FORM APPROVED
OMB NO. 1004-0137
Expires: January 31, 2018**SUNDRY NOTICES AND REPORTS ON WELLS**
*Do not use this form for proposals to drill or to re-enter an abandoned well. Use form 3160-3 (APD) for such proposals.*5. Lease Serial No.
NMLC029405B

7. If Unit or CA/Agreement, Name and/or No.
89200034108. Well Name and No.
MCA UNIT 269 ✓9. API Well No.
30-025-23706-00-S110. Field and Pool or Exploratory Area
MALJAMAR11. County or Parish, State
LEA COUNTY, NM**SUBMIT IN TRIPLICATE - Other instructions on page 2**

Permanent Abandonment of Federal Wells
Conditions of Approval (LPC Habitat)

WELLBORE SKETCH
ConocoPhillips Company -- Permian Basin Business Unit

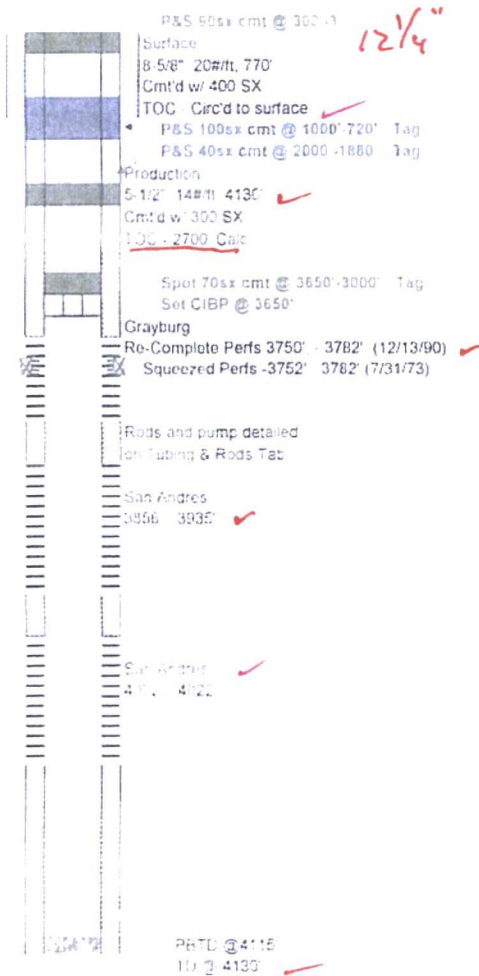
Handwritten notes:

A/salt 870

B/salt 1905

Qu 3062

GB 3444

SA 3820

Lovington 3964
